## BABCOCK BORSIG POWER®

Sender Rick Murray	Telephone/Fax Tel; 508-854-3872 Fax: 508-852-7548	Date March 5, 2003
Message to	Attention	Fax Number
Intermountain Power	Phil Hailes	435-864-6670
Total pages including this one three	It the transmission is incomplete or please call Office Services at (50

Attached are two sketches indicating the proposed stairway between the eighth plus floor and the ninth floor.

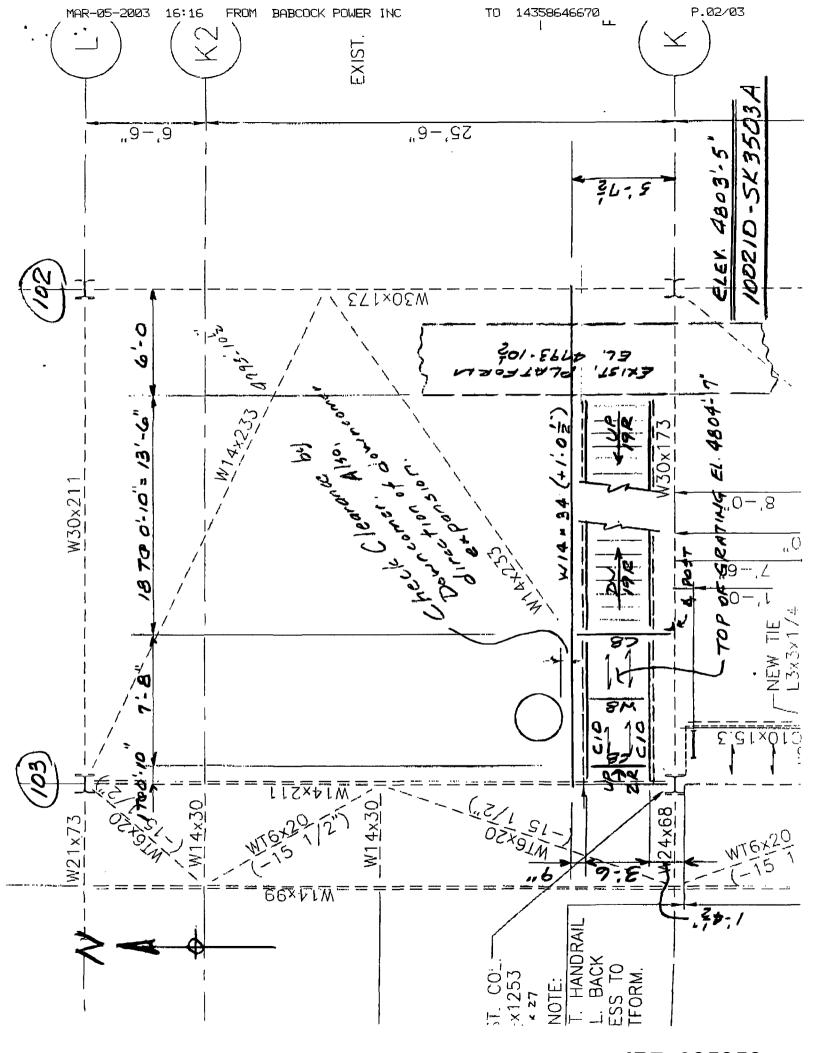
Please note that the stair on the east side of the unit was reduced to 3'-6" to clear both the column flange width and the downcomer. We also need to consider the direction and magnitude of the downcomer expansion, as we do not have much clearance at this time. To gain more clearance, we would most likely have to reduce the stair width to 3'-0".

Also, please note that we have moved the stairway on the west side a little further south to gain better clearance by the drain lines.
